SERVICE BULLETIN SB99.5

Machines/Models: AB46 Electric & Bi-Energy

1000-1768

PURPOSE: Filter control signal.

Figure 1

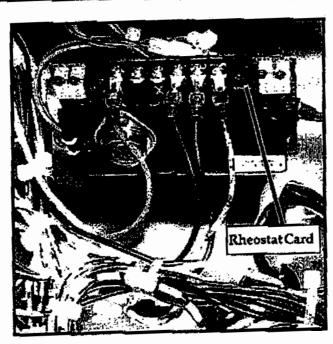
- 1. Disconnect the negative terminal from the battery.
- 2. Locate rheostat card in upper control box. See Figure 1.
- Remove red wire from + terminal on rheostat card.
- 4. Attach red wire, removed in step 3, to + terminal on Rheostat Filter (#068593-012).
- Remove black wire from terminal on rheostat card.
- 6. Attach black wire, removed in step 5, to terminal on Rheostat Filter (#068593-012).
- 7. Attach red wire from filter to + terminal on rheostat card. See Figure 2.
- 8. Attach black wire from filter to terminal on rheostat card. See Figure 2.
- 9. Attach Rheostat Filter to black wire with tie wraps as shown in Figure 2.
- Reconnect negative battery cable.
- 11. Perform Pre-Operation and Safety Inspection as instructed in the Operator Manual.
